## Bid Bulletin No. 8

### PUBLIC BIDDING No. 20 – 022– 3

## CONSTRUCTION OF ASCOM FACILITIES AT CAMP AQUINO, TARLAC FOR THE BASES CONVERSION AND DEVELOPMENT AUTHORITY

**BDS Clause 5.4**  
**Page 37**

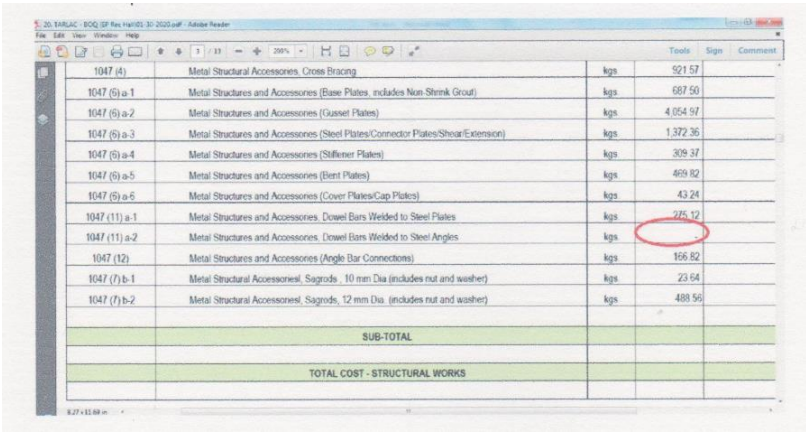
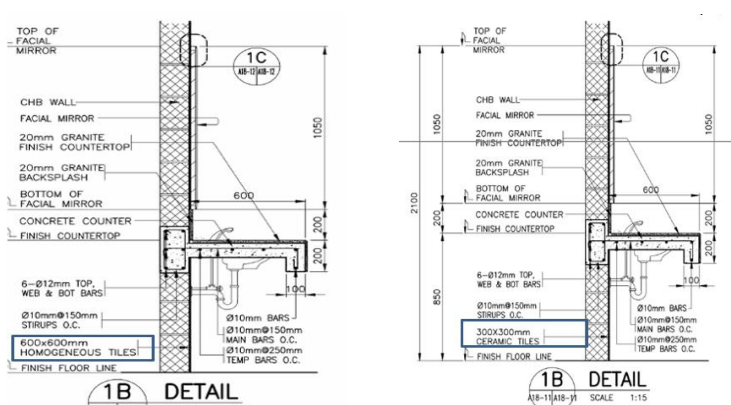
For this purpose, the SLCC shall only refer to a single contract implemented in the Philippines for the construction of multi-storey building. The cost of single-storey building/s in the contract shall not be included in determining compliance with the SLCC.

To amend the requirement on the SLCC (the proof of SLCC, if not implemented in the Philippines, shall be duly acknowledged and authenticated by the Philippine Consulate in the country of origin upon submission during post qualification).
